Amendments to the Drawings

Title: Adjustable Nasal Mask

Serial No. 10/786,524 Filing Date: 02/25/04 ANNOTATED SHEET SHOWING CHANGES

FIG. 30

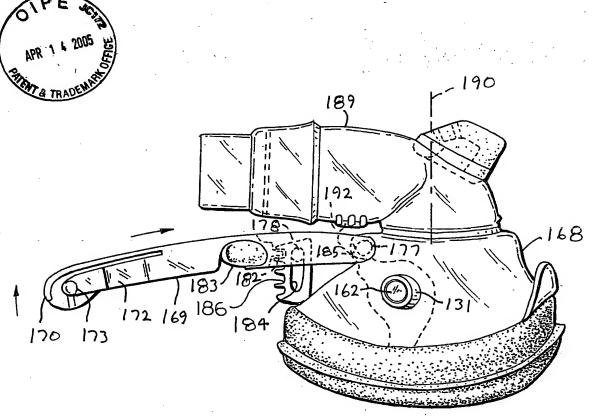
The attached sheet 15 of drawings includes changes to Figs. 30 and 31. This sheet replaces the original sheet 15 including Figs. 30 and 31. In Figs. 30 and 31, previously omitted reference numbers have been added.

Figs. 30 and 31 of the drawings are amended by adding reference numbers which are present in the specification but mistakenly omitted from these drawings. With the amendments, it is submitted that the drawings now comply with 37 CFR §1.84(p)(5). Both an annotated sheet and a replacement sheet are provided for sheet 15 of the drawings.
